APPLICATION NO.	FILING DATE	FIRST NAMED INVENTOR	ATTORNEY DOCKET NO.	CONFIRMATION NO.
29/867,397	10/24/2022	Andreas Papenfuss	BMLP.D020 20/4025695	8428
69842	7590	06/24/2025		
Oppedahl Patent Law Firm LLC -- BMLP			EXAMINER	
P O Box 351240			DAVID, ALEXANDER JOSEPH	
Westminster, CO 80035				
			ART UNIT	PAPER NUMBER
			2938	
			NOTIFICATION DATE	DELIVERY MODE
			06/24/2025	ELECTRONIC

Creative tool

Examiner's Comment

Fig. 6

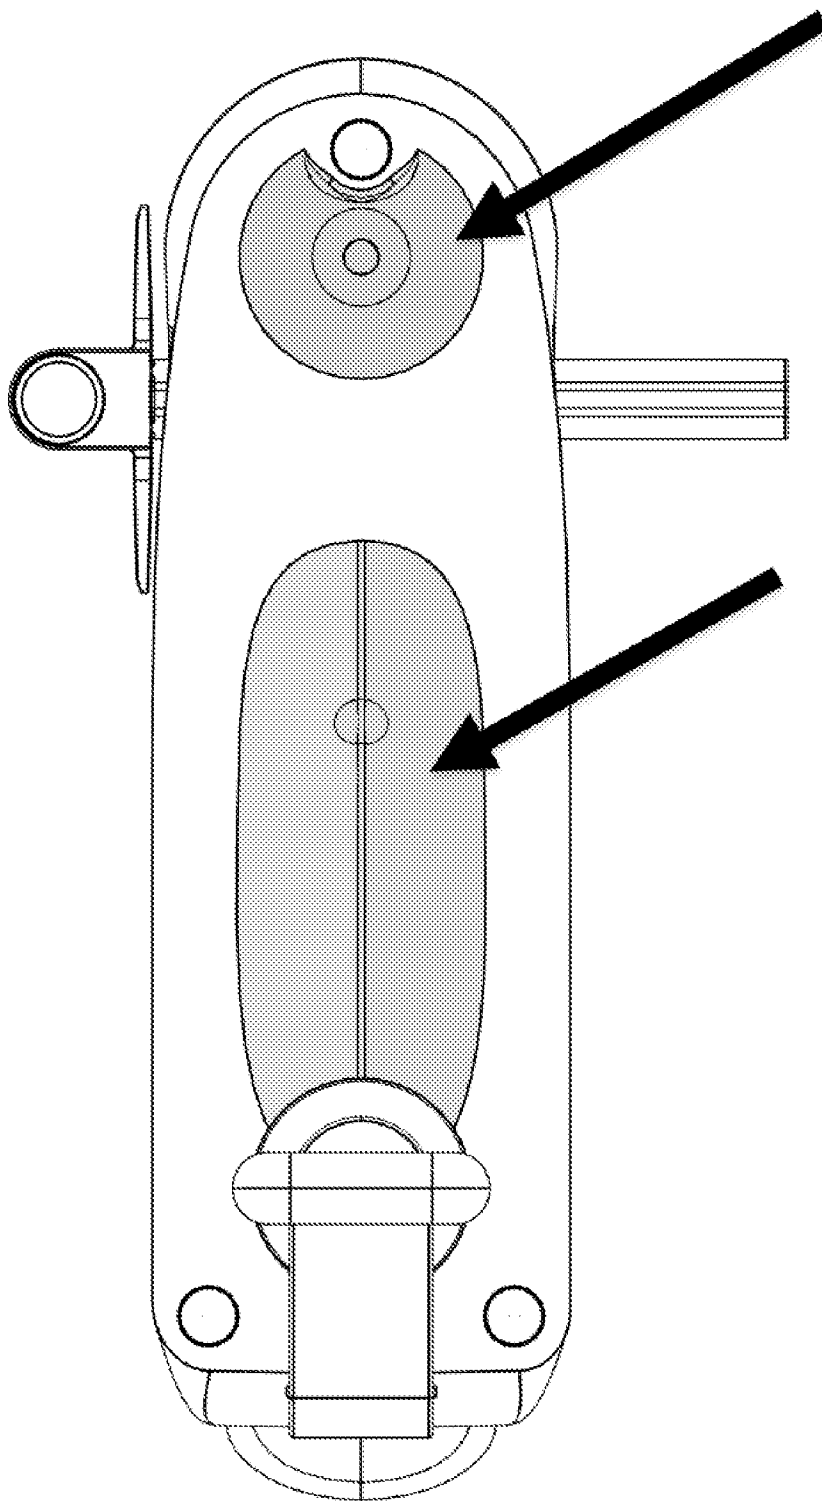
- In Figures 6 and 13 (Figure 6 shown), convert the areas WITHIN the highlighted grey areas to lightweight broken lines.

Fig. 11.

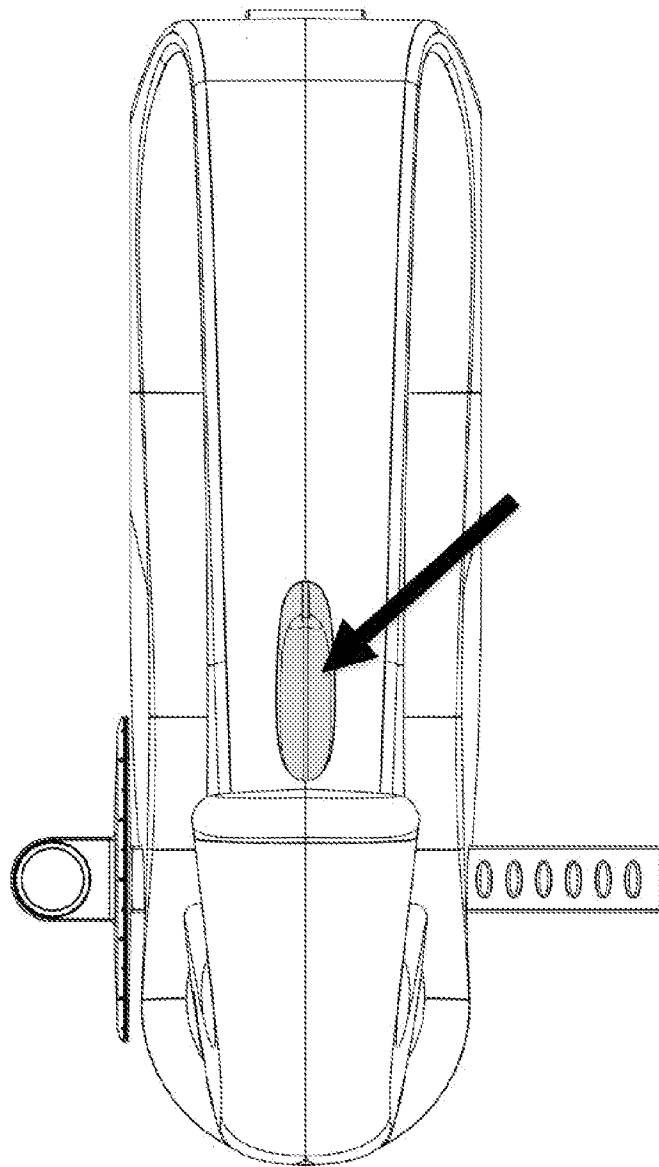
- In Figure 9, convert the areas WITHIN the light grey highlighted areas to lightweight broken lines, to include the elements annotated with circles.

- In Figure 9, convert the area WITHIN the grey highlighted area to lightweight broken lines.

Fig. 1

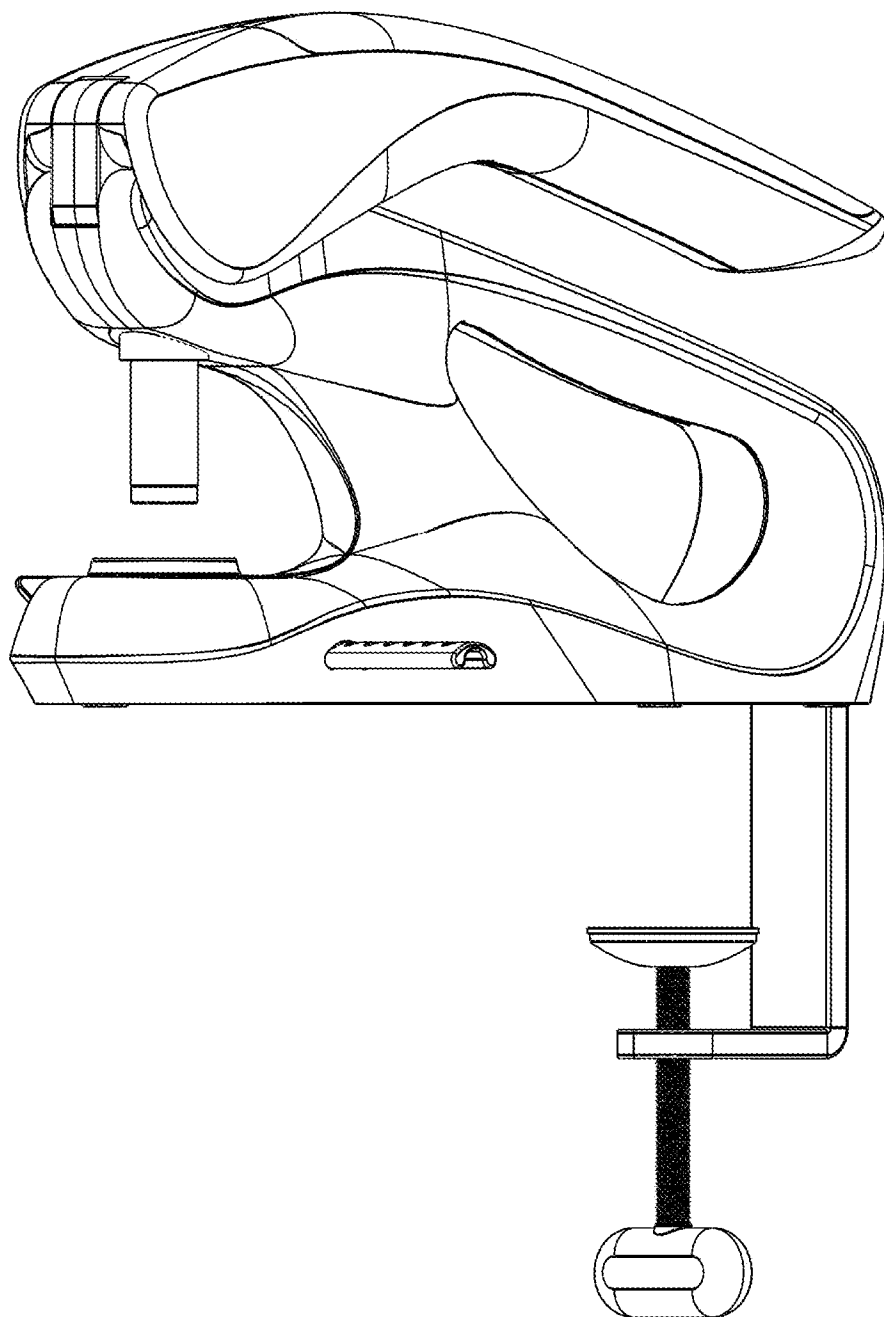
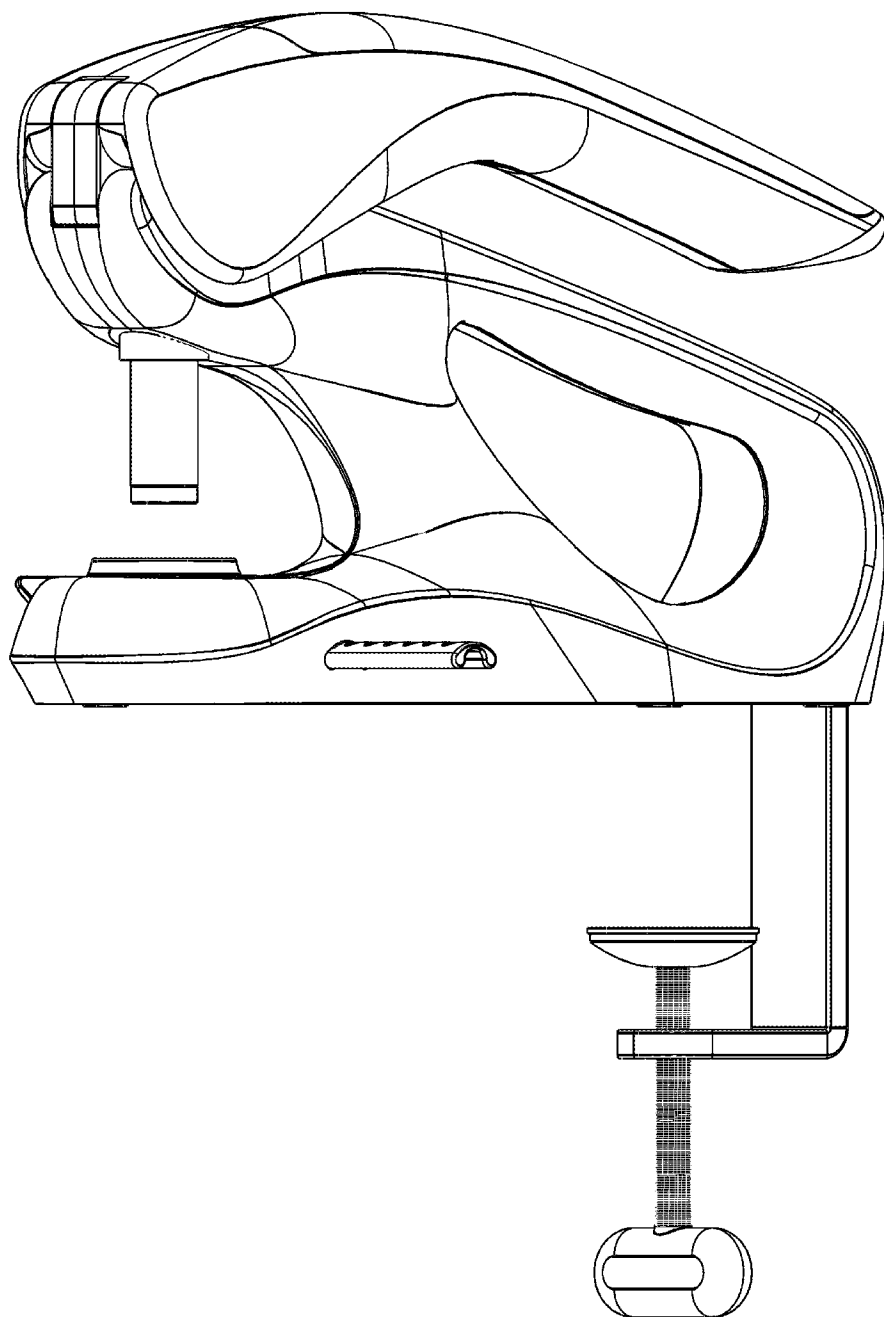
Circled zig-zag line. The Examiner finds fault with what is described as a “zig-zag line” in each of Figures 1 and 8. The undersigned is only able to see this zig-zag line by blowing up the figure to at least 150%. To avoid any further difficulty about this detail, the undersigned has carefully erased the detail. It is hoped that this issue is now eliminated.

- In Figure 1, shown below, the exact shape and design of the circled zig-zag line cannot be determined as it is only visible in a single view, and is thus indefinite and non-enabled.

Fig. 4

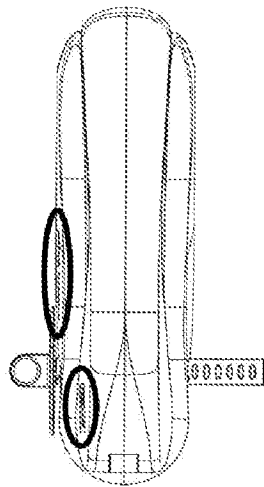
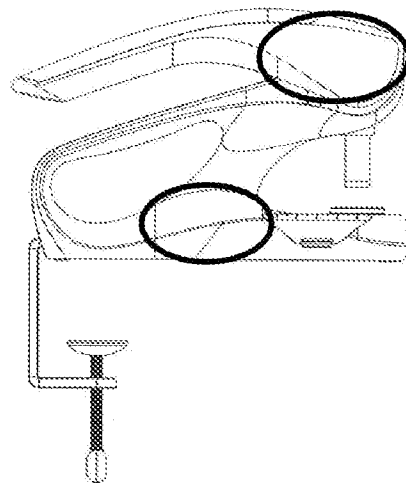
- In Embodiment 1, Figure 4, there is what appears to be a logo/writing on the side that is not visible in Figure 5.

Fig. 11

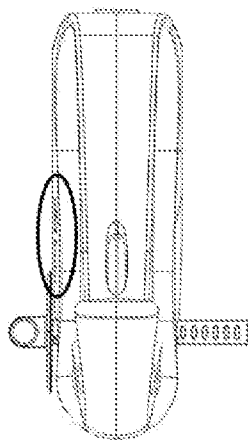
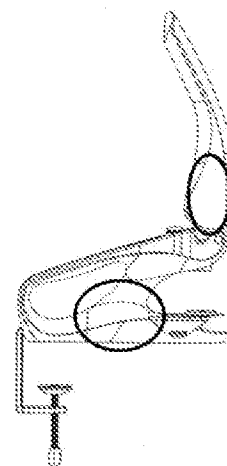
- In Embodiment 2, Figures 11 and 14, the logos/writing are present, but are absent in Figure 12.

Fig. 4

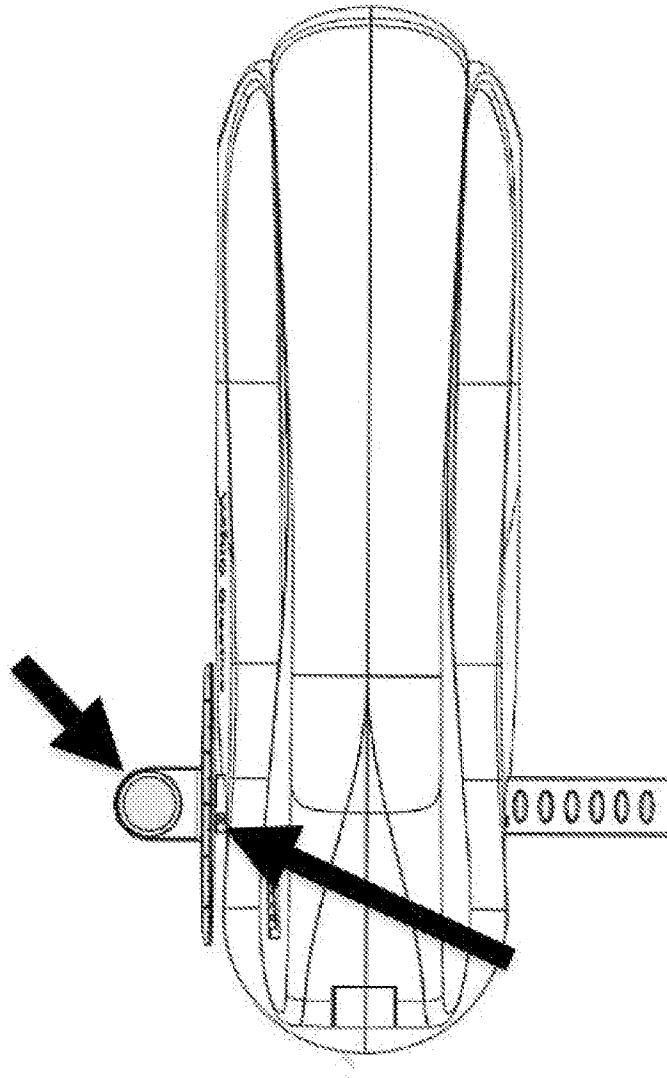
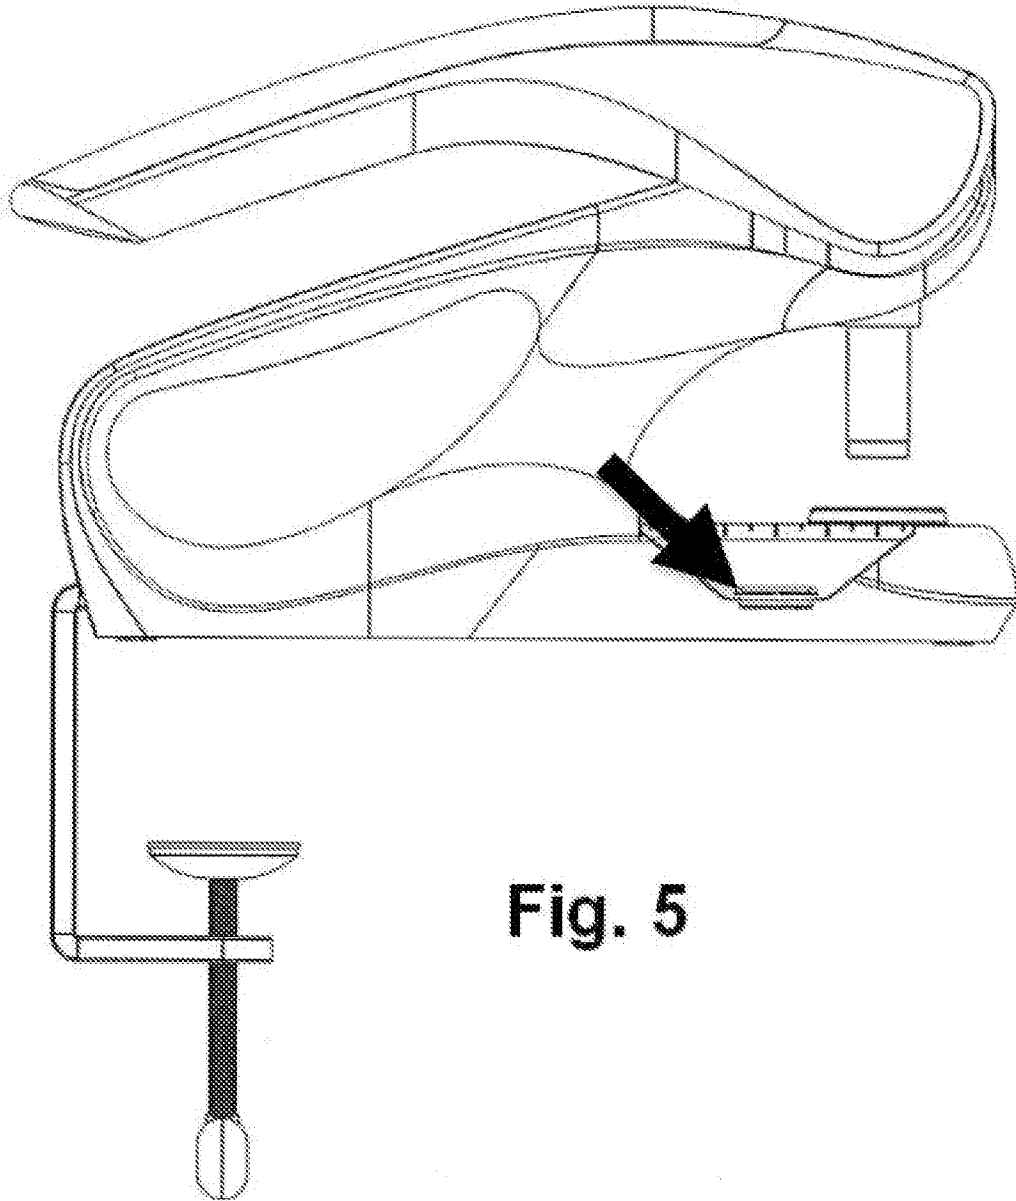
- In Figure 4 shown below, the inner circle of the highlighted area, as well as the portion below the adjustable stop are indefinite and non-enabled. The area behind the adjustable stop specifically because its shape and location cannot be determined from a single view. The highlighted circle area, because the dept and location cannot be determined from this view, with the poor line quality present in other views contributing to the issue.

Fig. 6

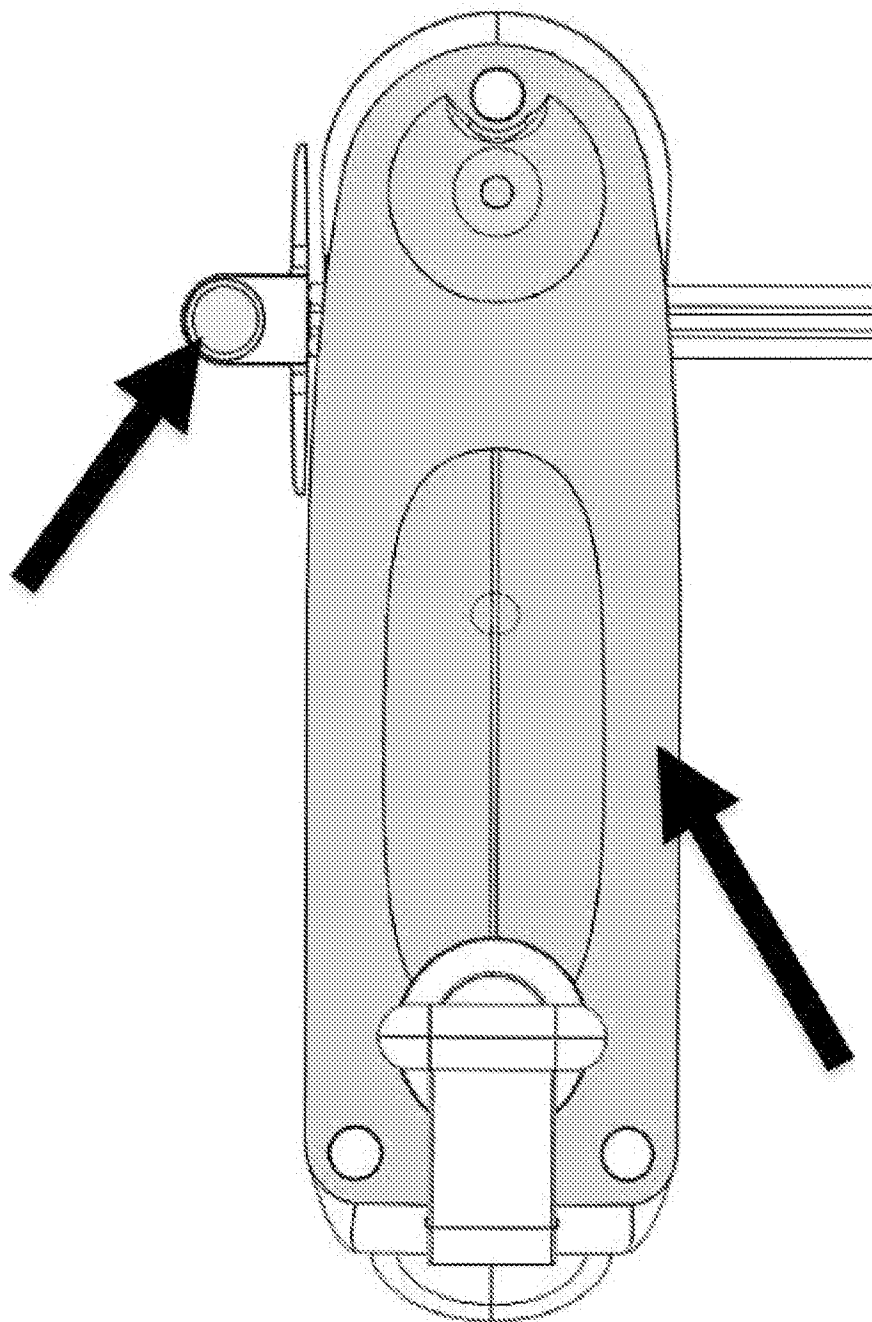
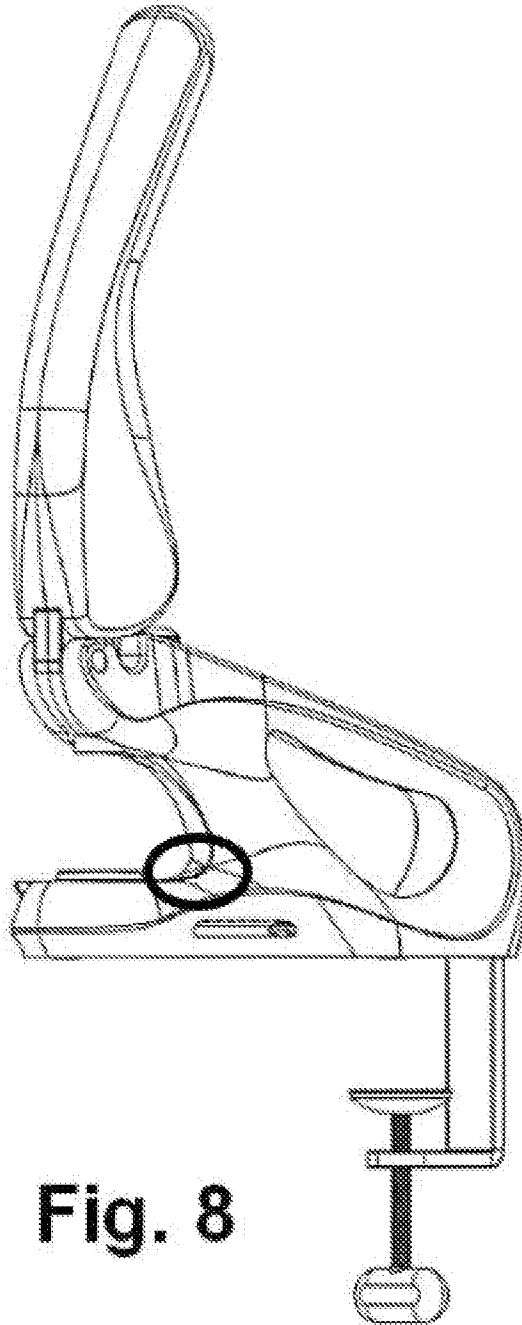
- In Figure 5 shown below, the area annotated with an arrow, where the adjustable stop meets the bar is indefinite and non-enabled as the shape and contour of this surface cannot be determined from a single view, with the poor line quality contributing to the issue as well.

- In Figure 6, shown below, the highlighted areas are indefinite and non-enabled as their shape and location cannot be determined from a single view.

Fig. 9

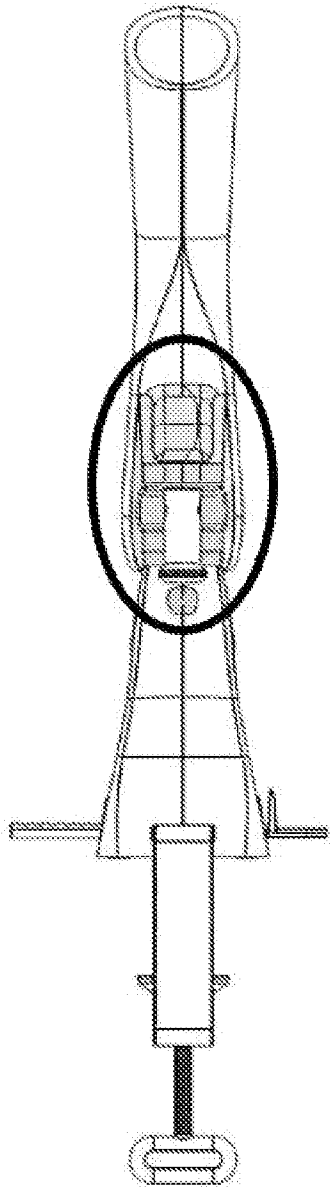
- In Figure 9, the highlighted areas are indefinite and non-enabled, as their shape and location cannot be determined from a single view. It is also the examiner's understanding that the un-highlighted area in the center of the circle is a cylinder.

Fig. 11

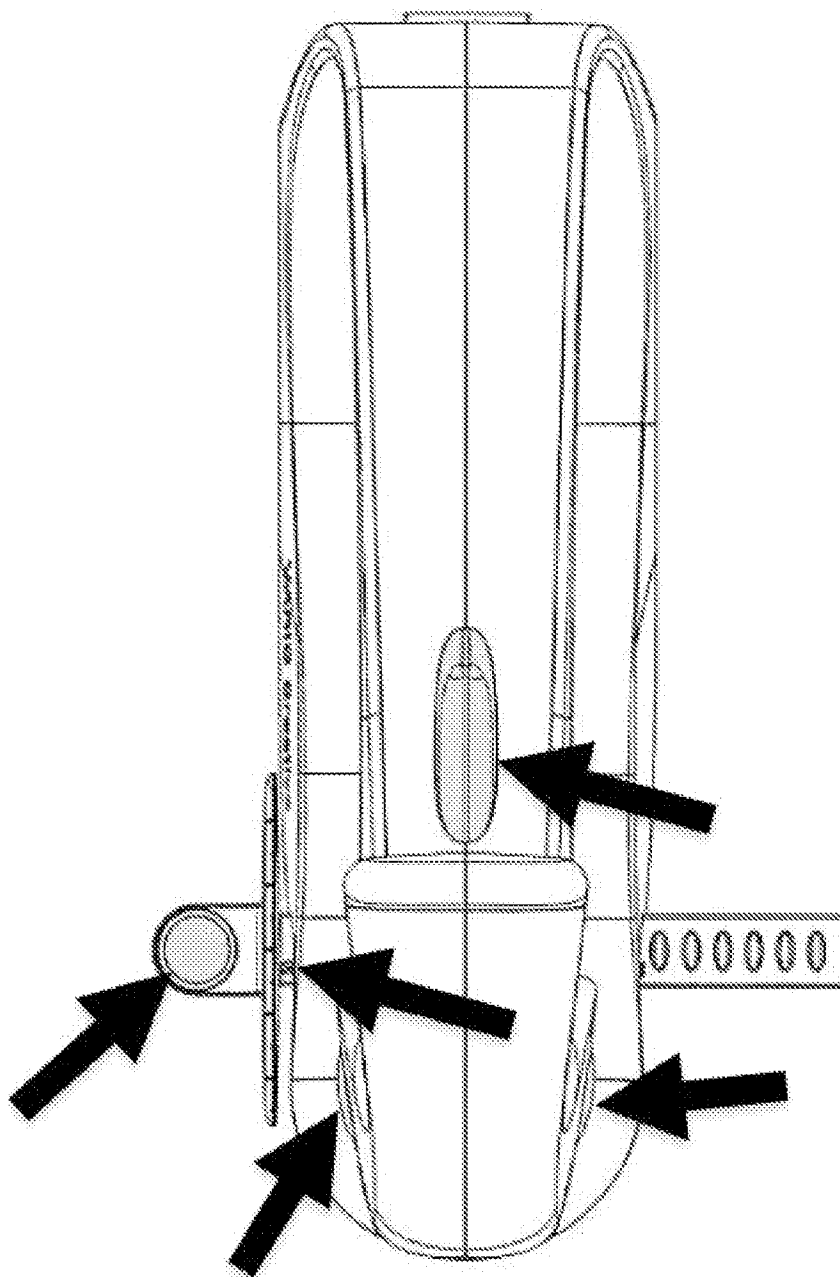
- In Figure 11, the highlighted areas are indefinite and non-enabled, as their shape and location cannot be determined from a single view.
